Docket Number:	22-IEPR-02
Project Title:	California Planning Library
TN #:	247067
Document Title:	Hills For Everyone Comments - Correction of solar and wind maps in Chino Hills region re biological resources
Description:	N/A
Filer:	System
Organization:	Hills For Everyone/Claire W. Schlotterbeck
Submitter Role:	Public
Submission Date:	10/28/2022 8:37:40 AM
Docketed Date:	10/28/2022

**Correction of solar and wind maps in Chino Hills region re
biological resources**

RE: Docket Unit, MS-4 Docket No. 22-IEPR-02
Comments on the Draft Staff Report for the Land-Use Screens for Electric System
Planning

Areas Targeted for PV Solar Installation in the Puente-Chino Hills

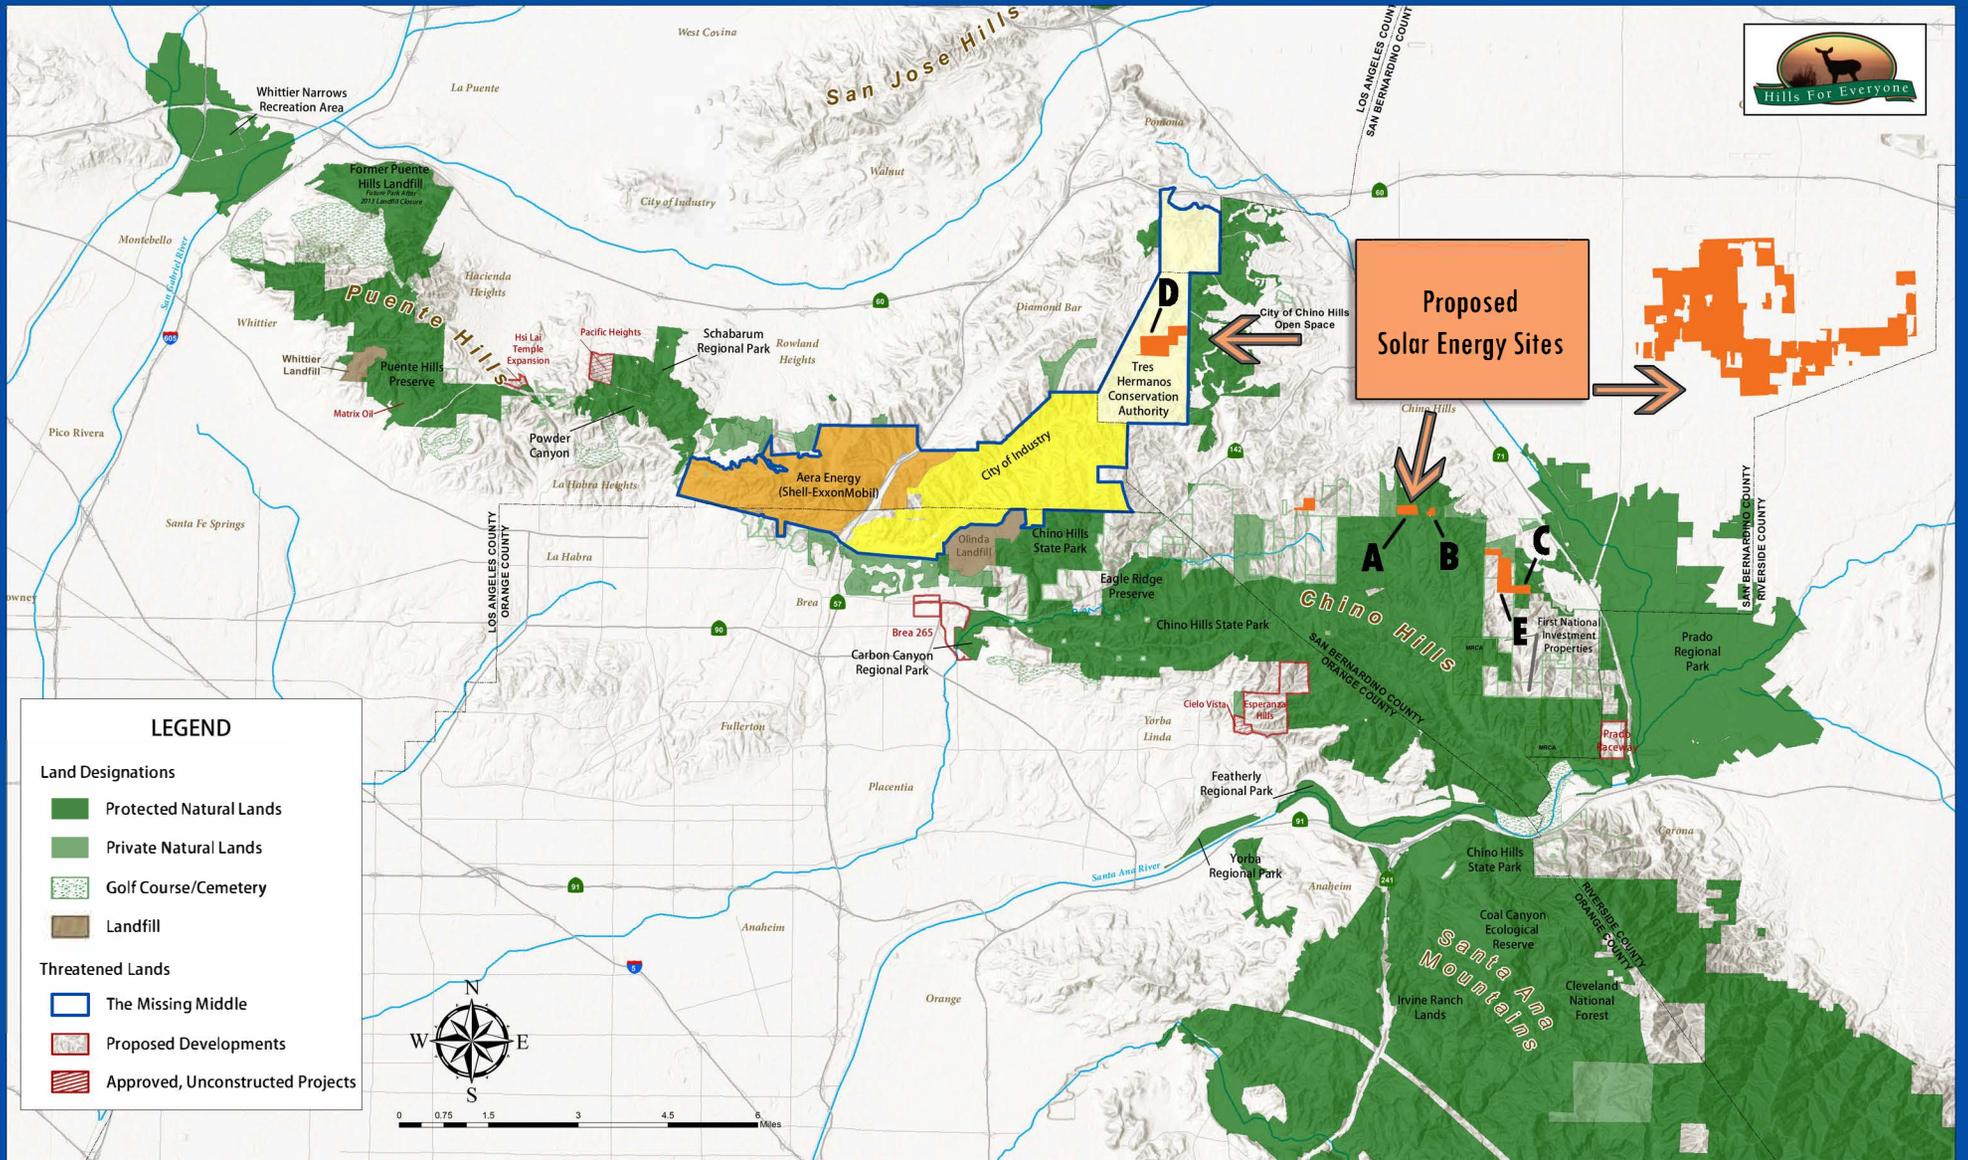
It is with this in mind, that we contest the inclusion of three locations on the Solar Photovoltaic Land-Use Screen 1 Map that presently are in protected status via ownership by the City of Chino Hills. Many of these lands were preserved as mitigation for development in the City and this designation thereby precludes them from future land use changes.

- Location A – West side of CHSP Entrance
- Location B – East side of CHSP Entrance
- Location C – East of CHSP, west of the 71 Freeway

We request removal of Locations A, B, and C as a potential solar photovoltaic energy sites.

We also contest the inclusion of one location on the solar photovoltaic Land-Use Screen 1 Map that is protected through a joint-powers authority (JPA) called the Tres Hermanos Conservation Authority (THCA). This JPA is made up of the Cities of Chino Hills, Diamond Bar, and Industry.

- Location D – Tres Hermanos Ranch lands in the City of Chino Hills

We request removal of Location D as a potential solar photovoltaic energy site.

While we understand the intent behind determining potential siting locations for energy infrastructure, we believe it important to acknowledge that one of the proposed locations includes lands the California Department of Parks and Recreation (CDPR), The Conservation Fund, and our organization are actively conserving. These lands include ridgelines that have been on the acquisition wish list since CHSP's inception.

- Location E – First National Investment Properties

We request removal of Location E as a potential solar photovoltaic energy site.

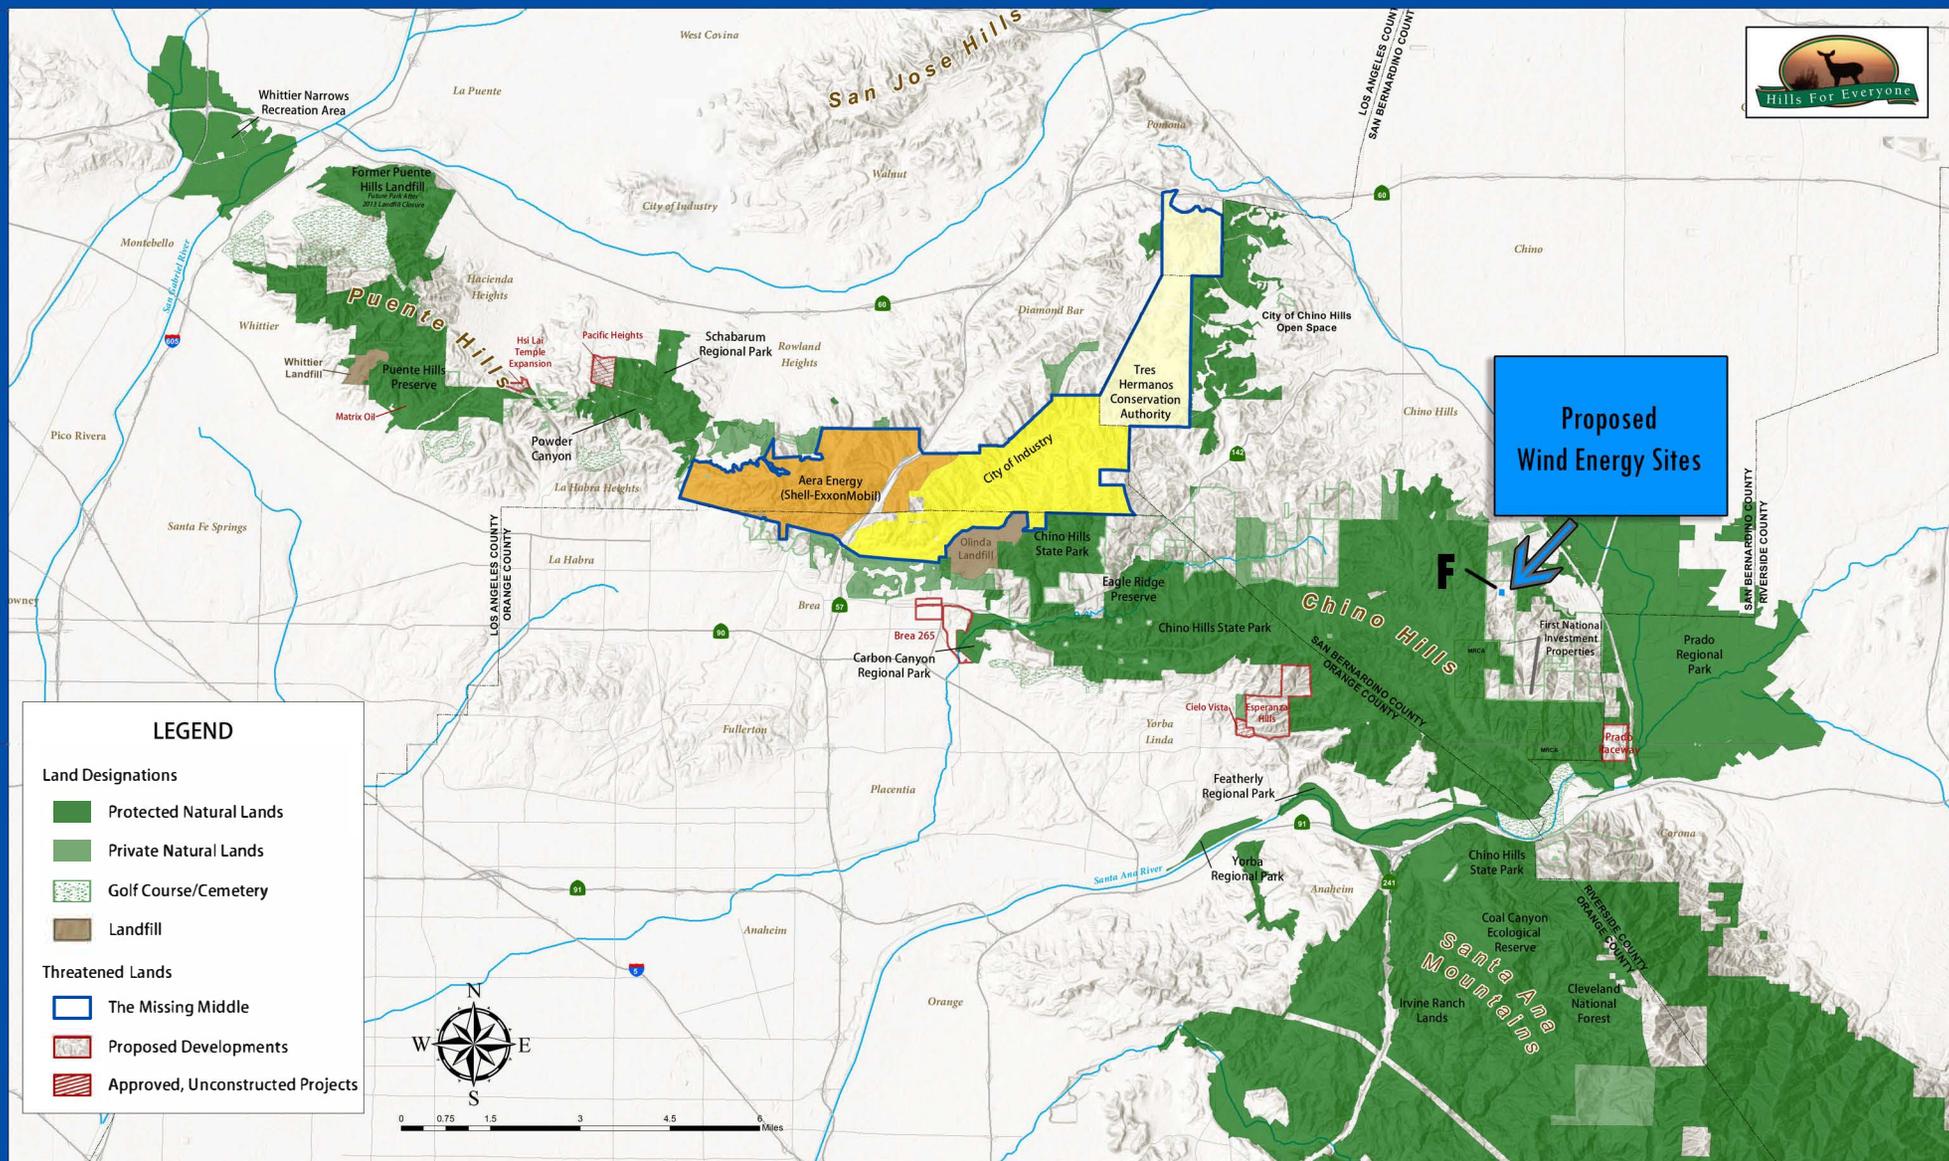
Similar to our comments above on this same property, the subject land is in the process of being conserved and a potential wind energy site has been located on the land. The reasons described above in the solar maps apply to the wind energy maps as well.

- Location F – First National Investment Properties

We request removal of Location F as a potential wind energy site.
